Feedback on Recommendations of the BMP Expert Panel for Agricultural Ditch Management Practices

Thursday, November 21, 2019
Ray Bryant, USDA-ARS, Panel Chair

Figure 15 in report. Basic components of a saturated buffer: 1. tile outlet, 2. water control structure, 3. perforated distribution tile or pipe, and 4. riparian buffer with established perennial vegetation. Adapted from <https://transformingdrainage.org/>

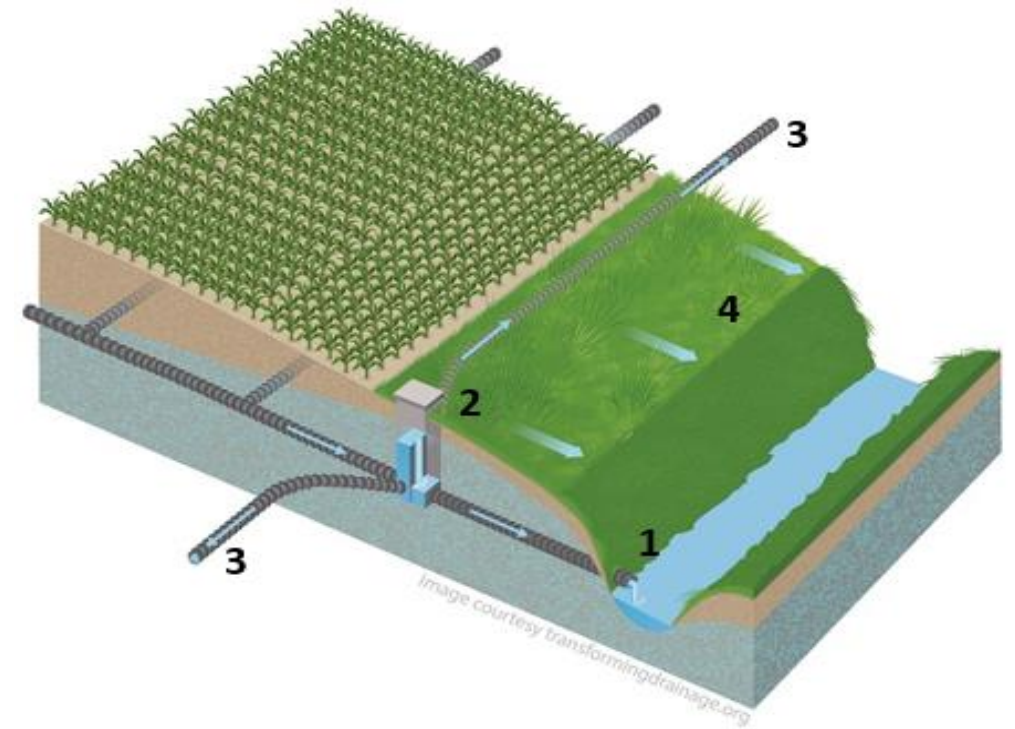
Is this practice "stackable" with existing buffers? Grass and Forest buffers? Narrow and full width buffers? Is there a minimum width? Does this practice replace/reduce the upland benefit of a buffer?

Riparian buffer practices are not 'stackable' because they each reduce loads from mutually exclusive acres within the model simulation.
